MODEL
XK, XJ,
S-TYPE

NUMBER
JTB00034

TECHNICAL BULLETIN

Noise when Turning Steering Wheel

Figure 1

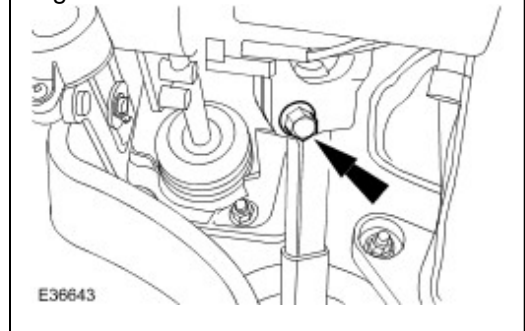
1. If the vehicle is an S-TYPE, perform the following steps:
 - Centralize the steering wheel and secure in place with a suitable brace.
 - Raise the vehicle on a lift.
 - Remove floor undertray.
 - Remove the upper steering column pinch bolt. (Figure 1)
 - Detach the lower steering column universal joint from the steering gear. (Figure 2)
 - Lower the vehicle on the lift.
 - Detach the lower steering column shaft from the upper steering column. (Figure 3)
 - Remove the lower steering column support bearing retaining nuts. (Figure 4)
 - Remove the lower steering column. (Figure 5)

Figure 6

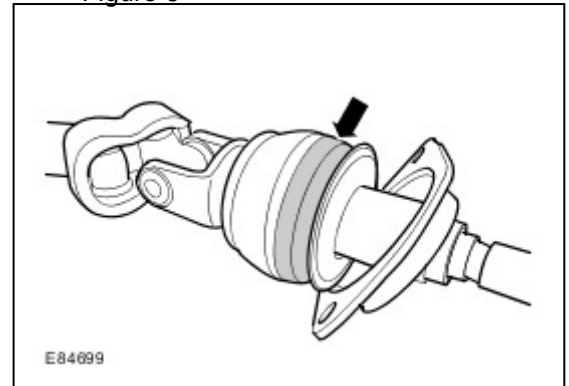
5. Check condition of the lower knuckle joint.
6. If there is a fault with the knuckle, repair the fault
7. Slide back the steering column retaining plate to gain access to the retaining plate rubber.
8. Grease the retaining plate rubber using two packs of KSP205 from the Squeaks and Rattles Kit (JLM21204). (Figure 6)

Figure 7

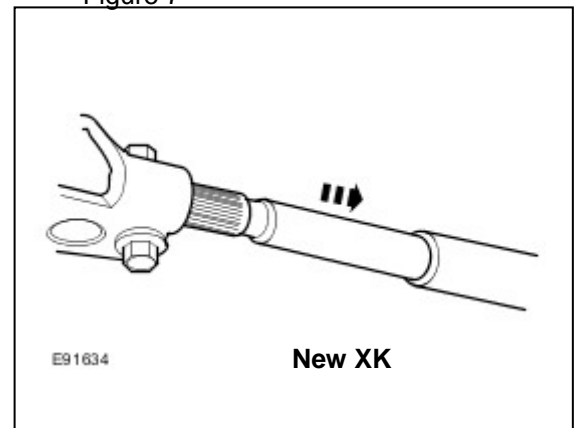
1. Place lower column to the vehicle.
2. If the vehicle is an XJ or New XK vehicle, refer to GTR Workshop Manual, section: 211-04 (57.40.05) to install and align the steering column lower shaft.
3. If the vehicle is an S-TYPE perform the following:
 - Install and align the lower steering column.
 - Install and tighten the lower steering column support bearing securing nuts to 9Nm (xx lbf.ft).
 - Reposition the lower column to the upper column.
 - Install and tighten the new pinch bolt to 35Nm. (xx lbf.ft).
4. Raise the vehicle on the lift.
5. Install and align the lower column to the steering gear.
6. Reposition the lower steering column swinging link to its lowest position. (Figure 7 for XK and Figure 8 for XJ and S-TYPE) .
